CARTER RESIDENCE
176 Little Marine Pde, Cottesloe

Response to Councillor questions made at Agenda Forum meeting on 18 May 2021

10.1.2 LOT 64 (176) LITTLE MARINE PARADE - TWO-STOREY DWELLING

Revised Submission on Proposed Two-storey Dwelling - Lots 64 & 65 (Nos. 176 & 178) Little Marine Parade, Cottesloe

OVERSHADOWING CALCULATION		Original Submission
21 June overshadowing component	= 202m ²	= 218m ²
Size of southern neighbouring site	= 438m ²	
202/438 x 100	= 46%	218/438 x 100 = 49.8%
Deemed to Comply % for R20 site	= 25%

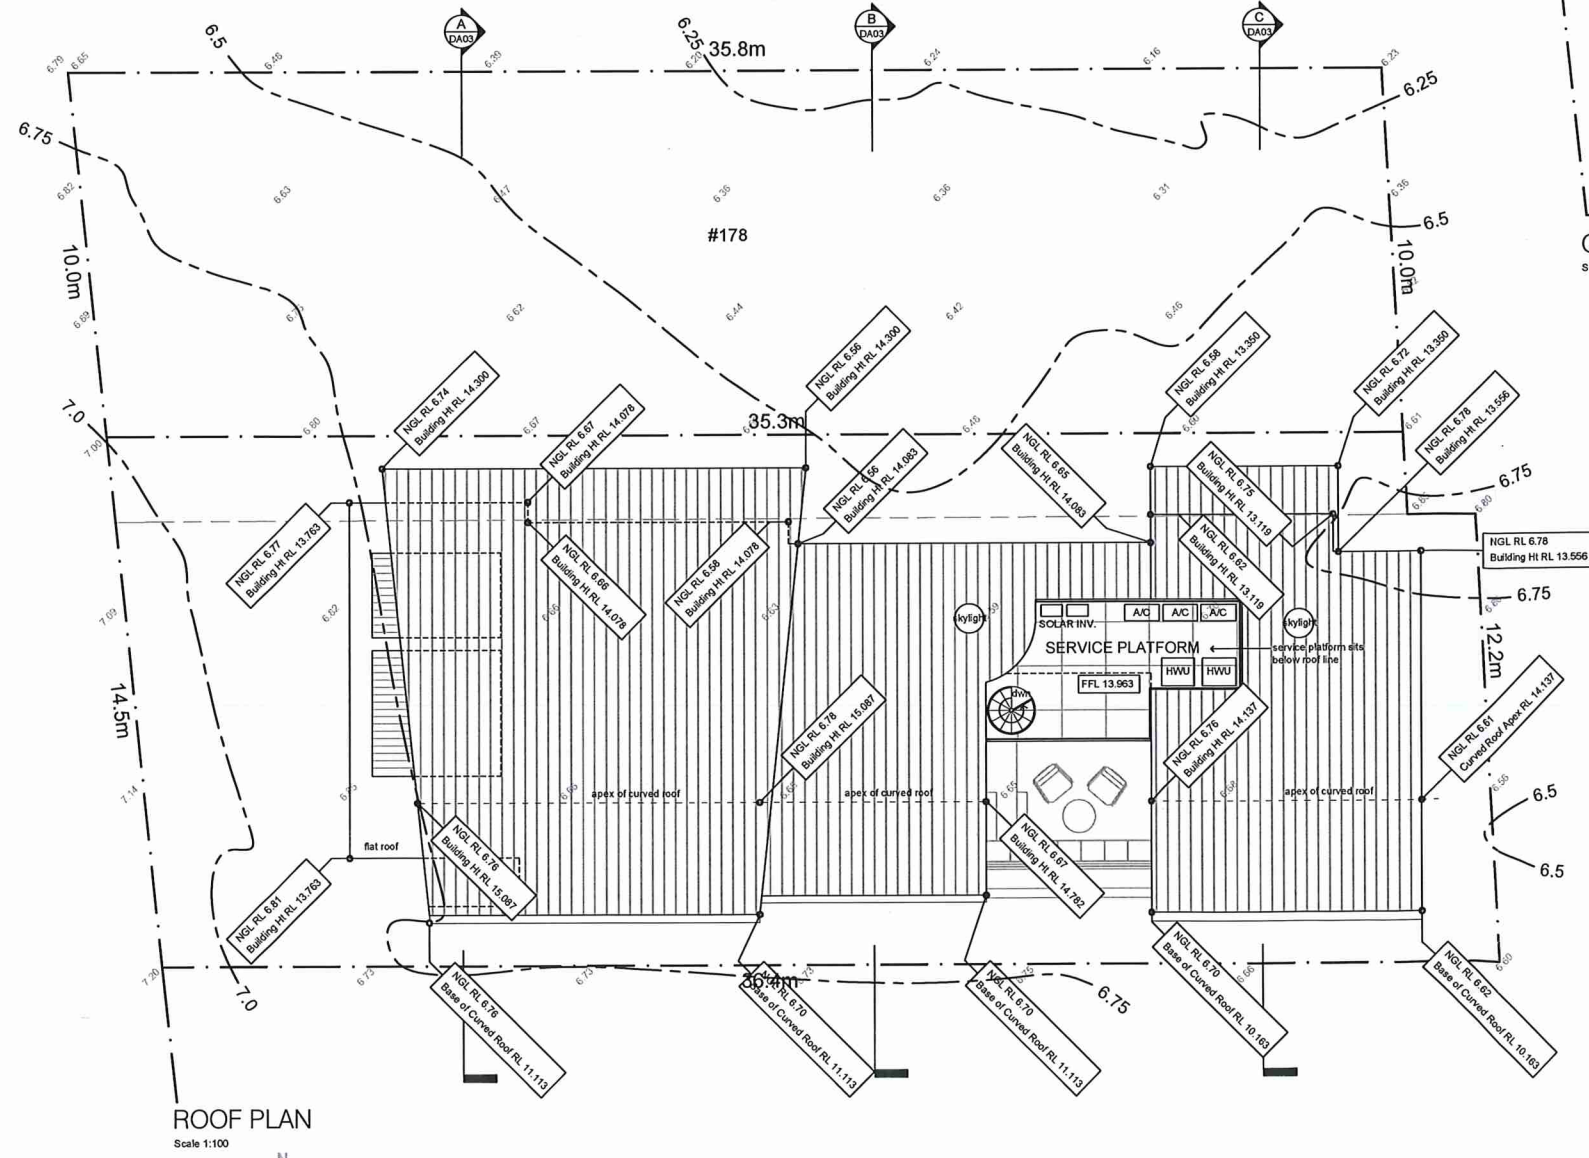
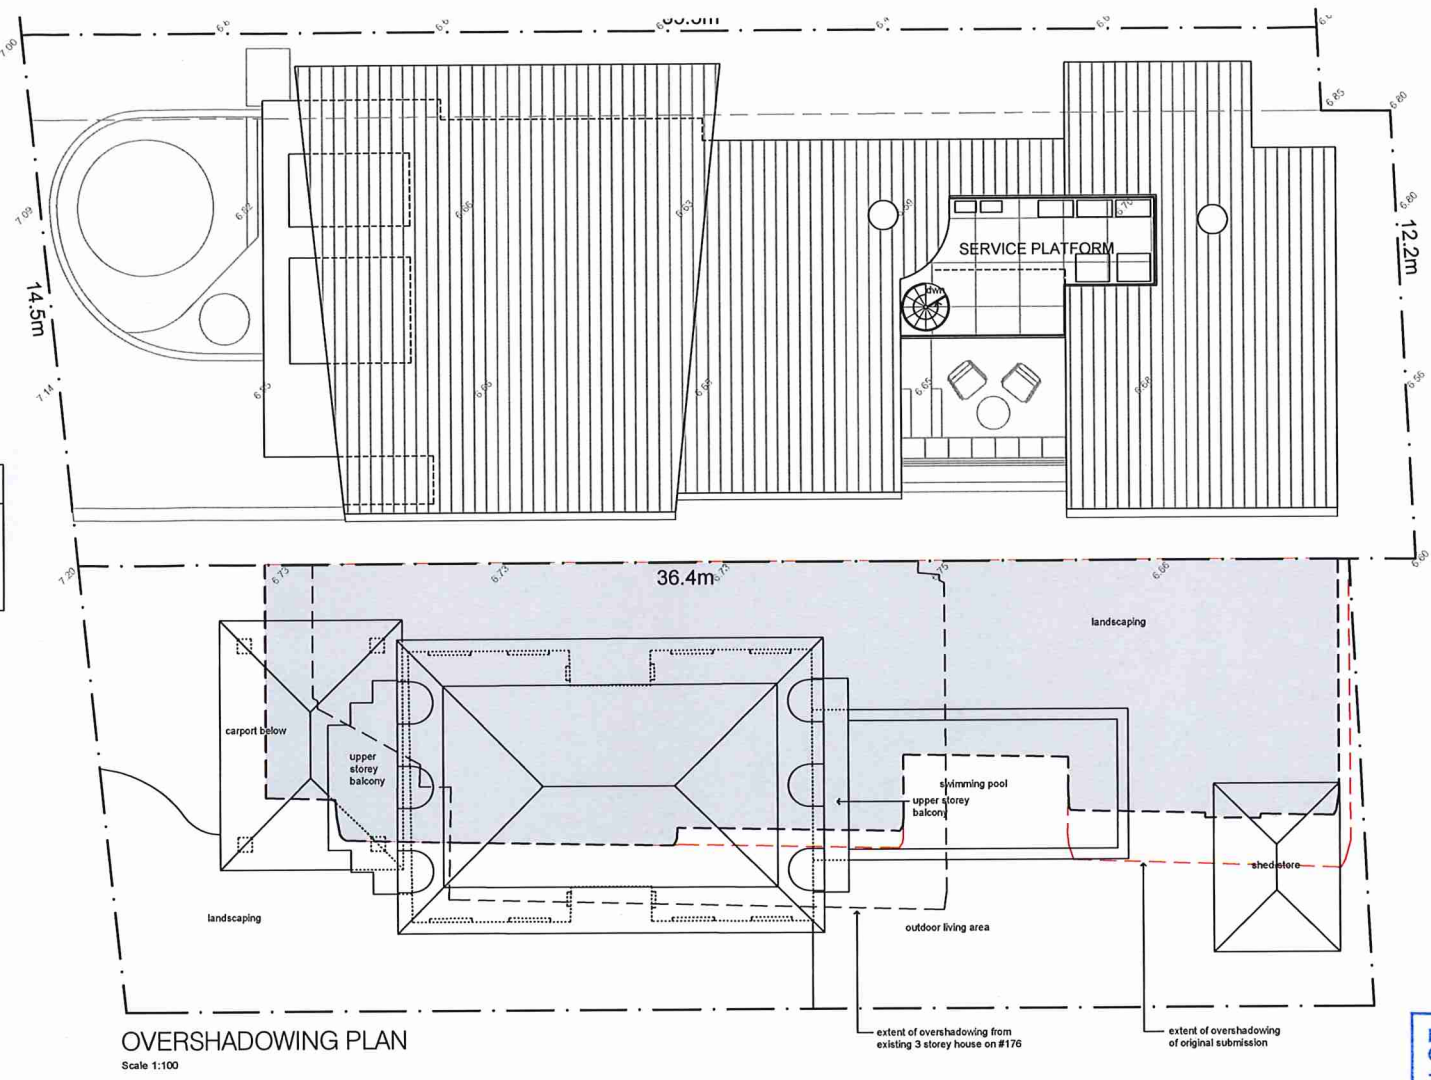
The proposed dwelling will overshadow the adjoining southern lot by approximately 50% (49.8%) which equates to approximately 218m² or nearly double the area permitted under the *deemed-to-comply* standard in the R-Codes (see below):

Above: Carport at front of the southern neighbour’s dwelling that may be partially overlooked by the proposed raised front courtyard.

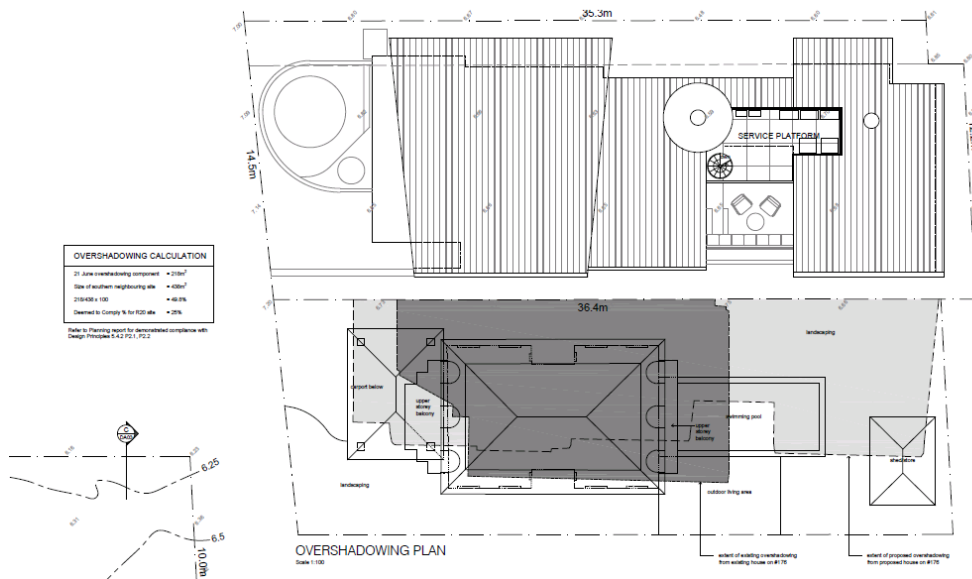
Following the applicant's response, the Town is satisfied that as the only area that would be overlooked within the required cone of vision is the southern neighbour's front carport, rather than any active habitable spaces and outdoor living area, it may be supported under *design principles*.

Above: Diagram supplied by applicant showing 32% overshadowing of the adjoining southern lot from the existing dwelling

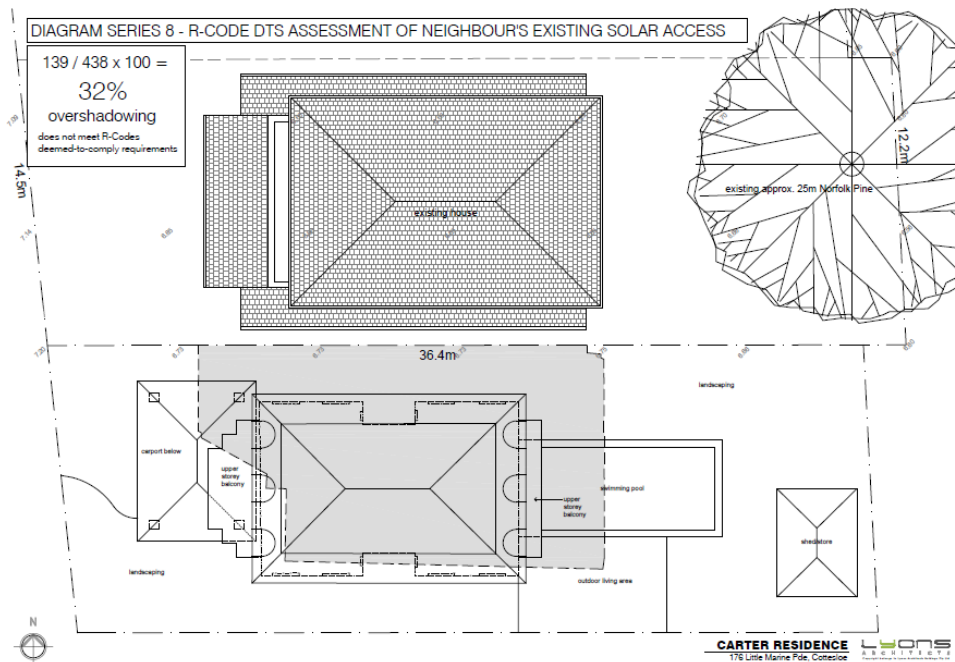
In this case, it is evident from the plans that all of the north-facing windows and much of the east and west facing openings on the southern neighbour's dwelling are already overshadowed on 21 June and therefore the proposed development will make little difference. Furthermore, a large Norfolk Island Pine tree at the rear of 176 Little Marine Parade also would cast some shadow over the adjoining southern lot.

Above: View from rear of No. 174 Little Marine Parade looking north-west (photo supplied by Altus Planning)

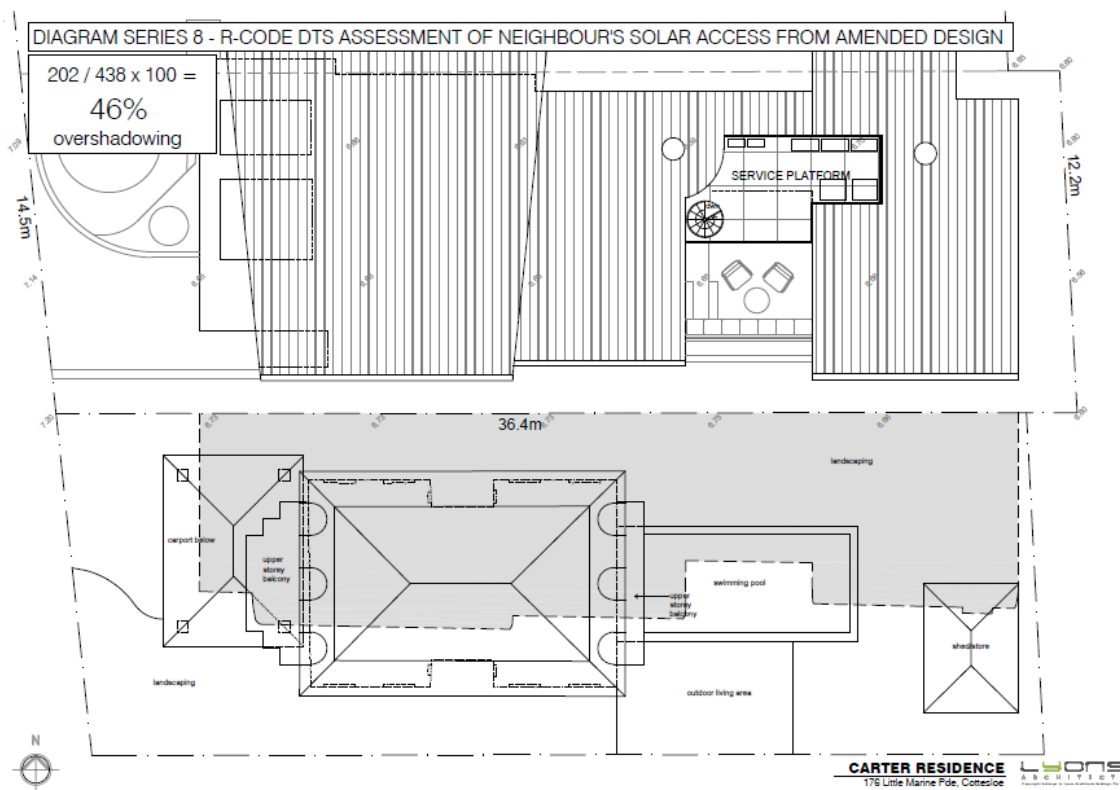
Whilst it may not be possible to expect the entire rear courtyard of the southern neighbour’s property to be unaffected by overshadowing, it nevertheless doubtful that the current proposed dwelling has been adequately designed to protect sufficient solar access to enable it to be supported under *design principles*.

Above: Diagram supplied by applicant showing 46% overshadowing of the adjoining southern lot if proposed revisions were undertaken

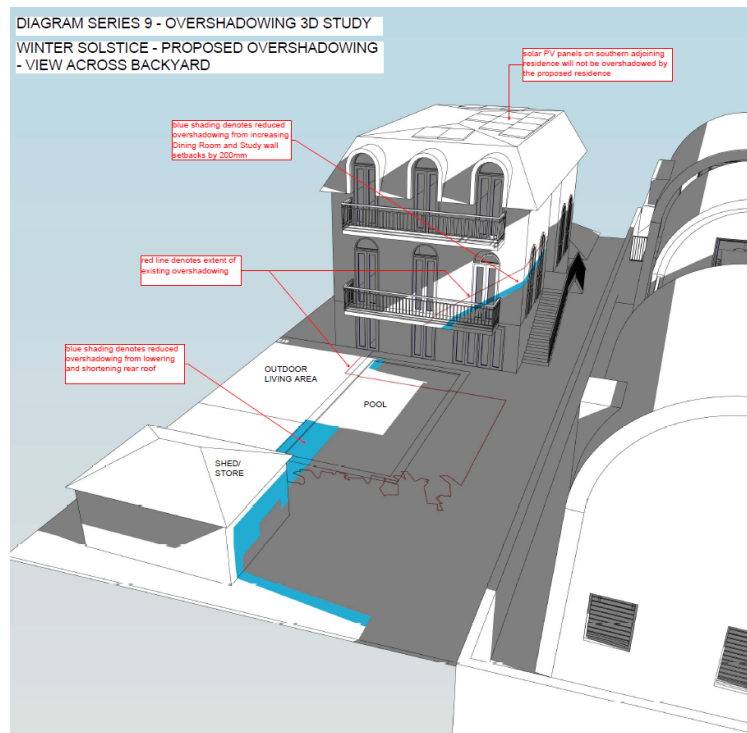
However, if the applicant’s revised proposal to lower the height of the roof over the rear section by 0.95m and shortening its length by 0.45m was submitted for consideration then based on the applicant’s analysis the overshadowing from the proposed development would be reduced to 46% or 202m², which is 16m² less than the current proposal.

Photo 2 - Calculated outdoor living area.

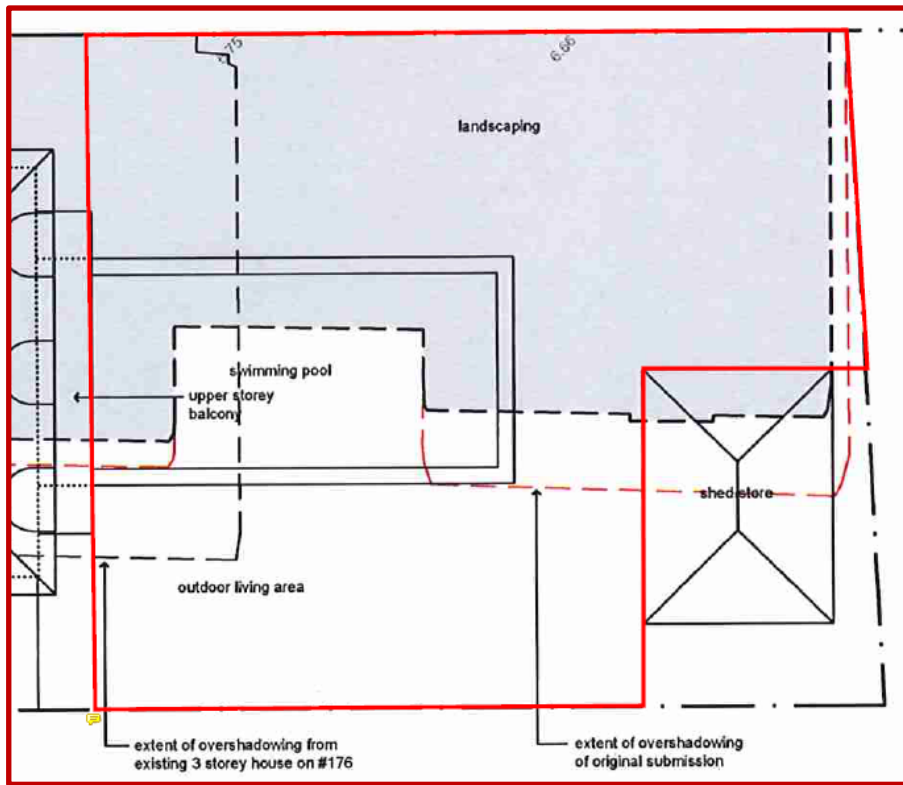
- The overshadowing plan illustrates that approximately 86m² (57.3%), or nearly two-thirds of the OLA, will be overshadowed by the revised proposal.
 - By way of comparison, the existing dwelling on No. 176 overshadows approximately 32m² (21.3%) of this same 150m² OLA which is approximately one-third less.

Photo 2 - Calculated outdoor living area.

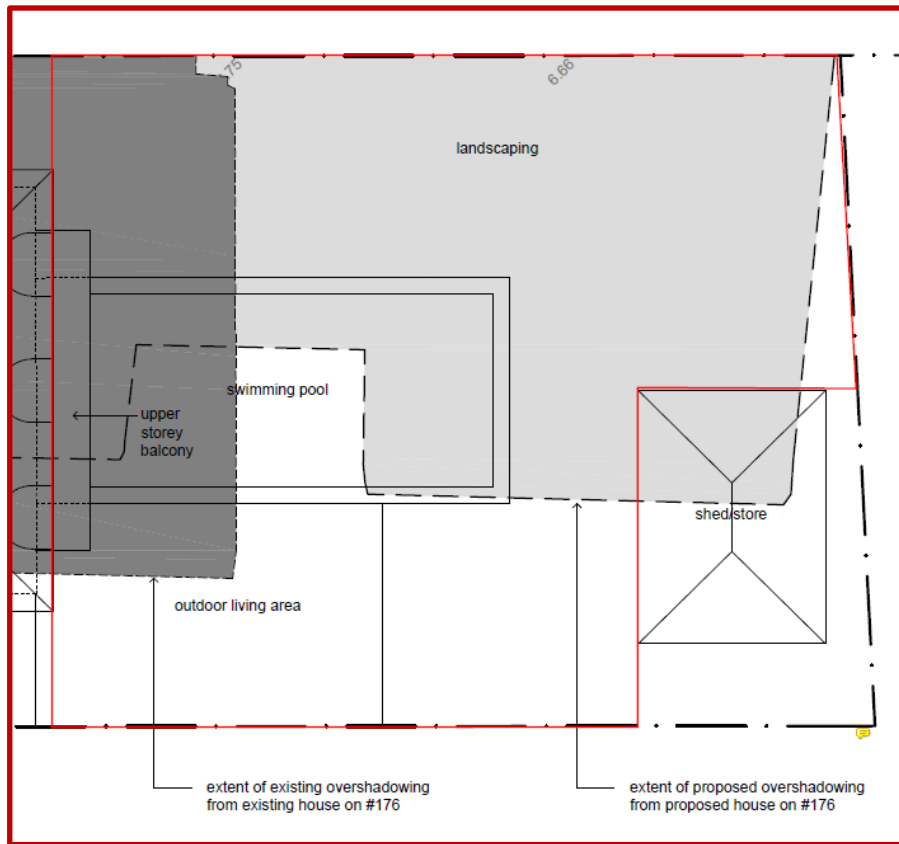
- With respect to the rear open space of No. 174, approximately 150m² is available as a usable outdoor living area (i.e.. excluding the outbuilding and surrounding south-east portion of land) (**refer Attachment 1, Photo 2**). The diagram provided by the applicant (*Sheet DA04*) illustrates that approximately 92m² (61.3%), or two-thirds of No. 174's outdoor living area (OLA) will be overshadowed by the proposed dwelling.
